Edits Made to TSI Rev.6 Board for Next TSI Revision

Note: things in red are unresolved.

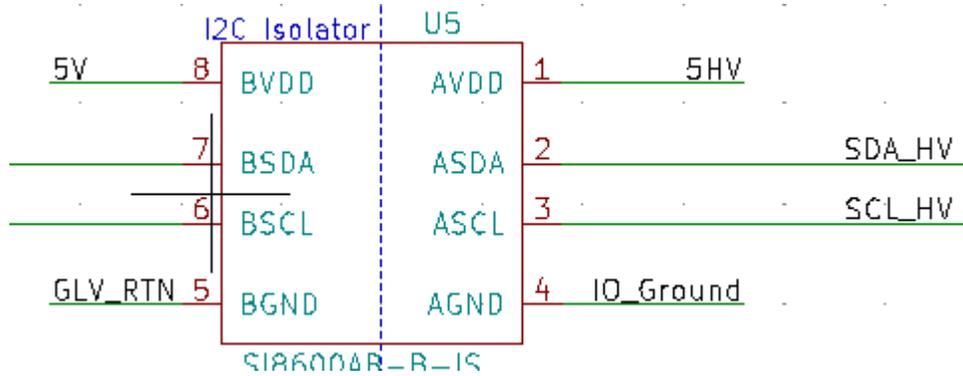
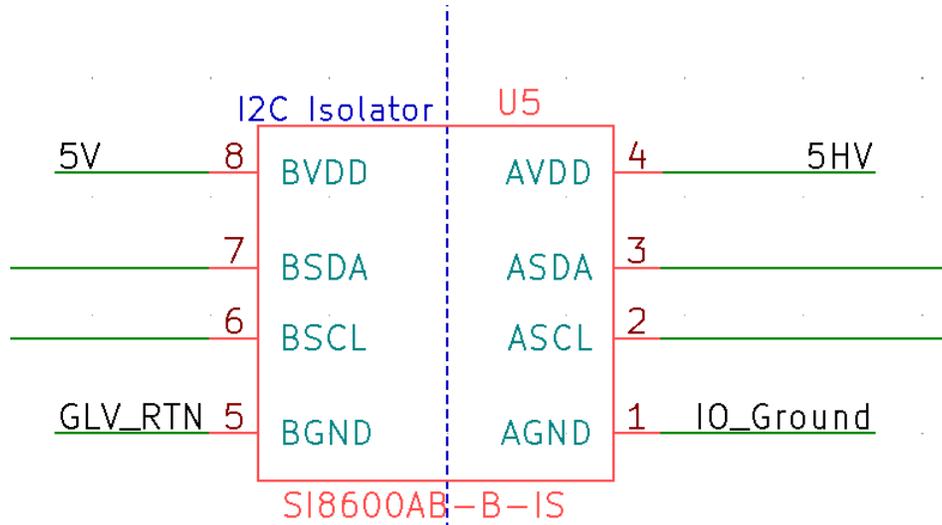
1. MC_95% Signal should actually be PC_Control as seen below, flywire needs to be added to board. This is an artifact from TSI Rev. 4's board. They had two separate pre charge ready signals, they were "Precharge Ready" and "Pre charge Ready." We thought this was a mistake and removed the "pre charge Ready" signal from the schematic. Thus leading to the current confusion. (edits made on TSI schematic and pcb schematic)
2. 10/14/21 – EC – Flywire added to board. This issue has now been resolved.

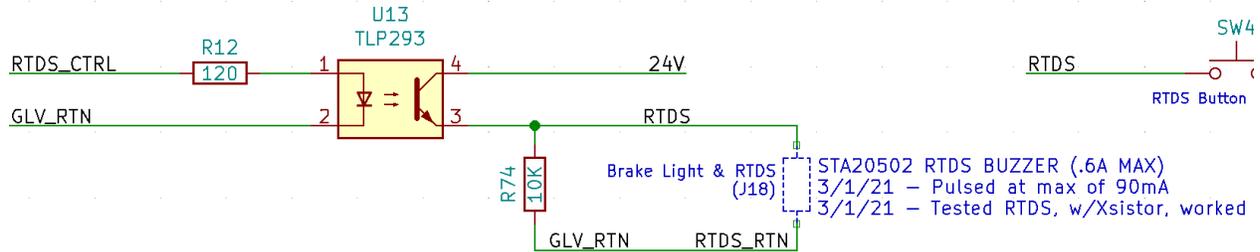
1. RTDS TLP (U13) gets very hot if RTDS is left on too long. Not an issue we were concerned with because technically RTDS should be only on for about two seconds. Could be remedied in later design.

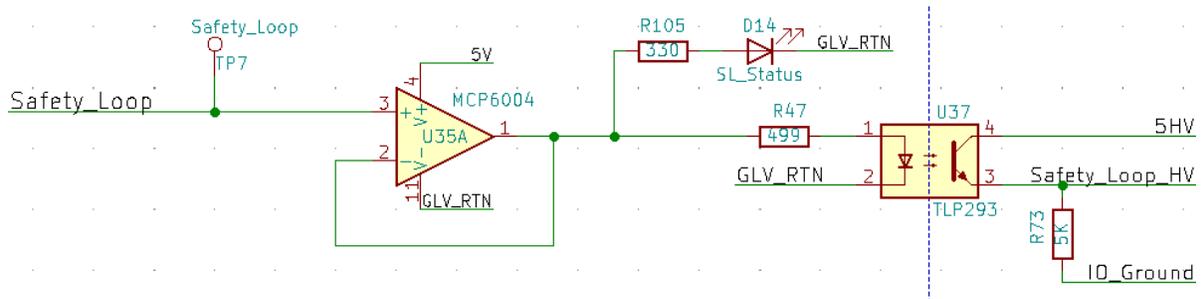
2. Changed U35A's rails from 3.3V to 5V on schematic
3. 10/22/21 – EC – Cut connection to 3.3V and added flywire to 5V on the board. Change needs to be made on PCB Layout

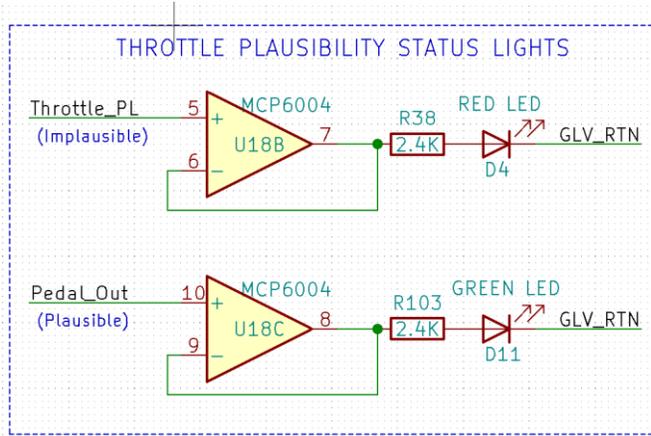
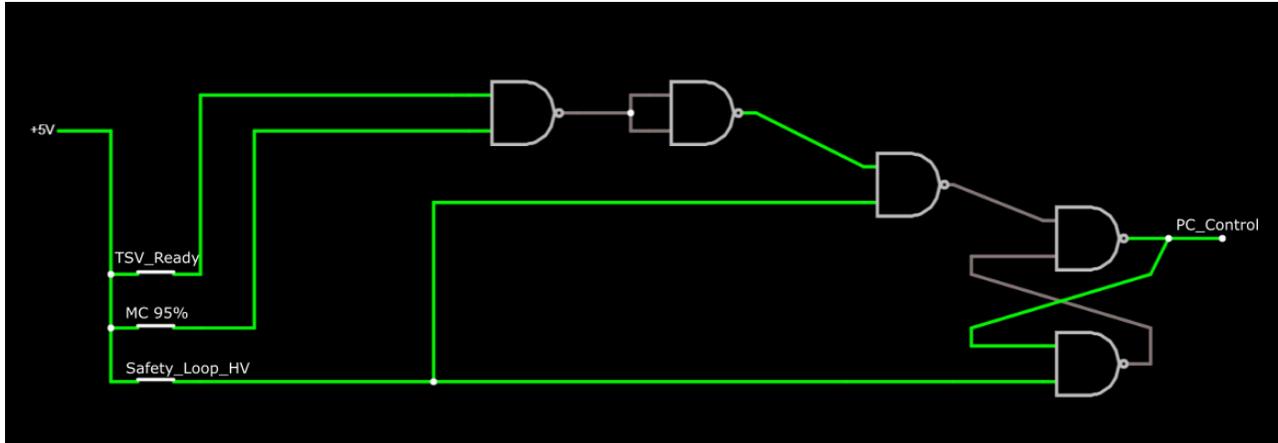
D4 on backwards or burned out. To drive D4 and D11, should not use the actual throttle_pl and Pedal_out signals. Example: as when pedal_out is around a volt (you're driving the throttle voltage of the motor) the LED doesn't come on.

10/26/21 – EC – D4 replaced on the board. Driving it with Throttle_PL is in fact fine since it is the output of an AND gate and thus will be 5V when the D4 is supposed to turn on. D11 doesn't actually seem to serve much purpose and could be removed in a later revision since we don't care whether Pedal_out is on or off, we care about its actual voltage. If anything, U18C's inverting terminal could be connected to a .24v reference so that D11 turns on whenever Pedal_out is in it's .24V to 4.76V range, and turns off when Pedal_out gets shorted to ground (which happens when the throttle is determined to be implausible)
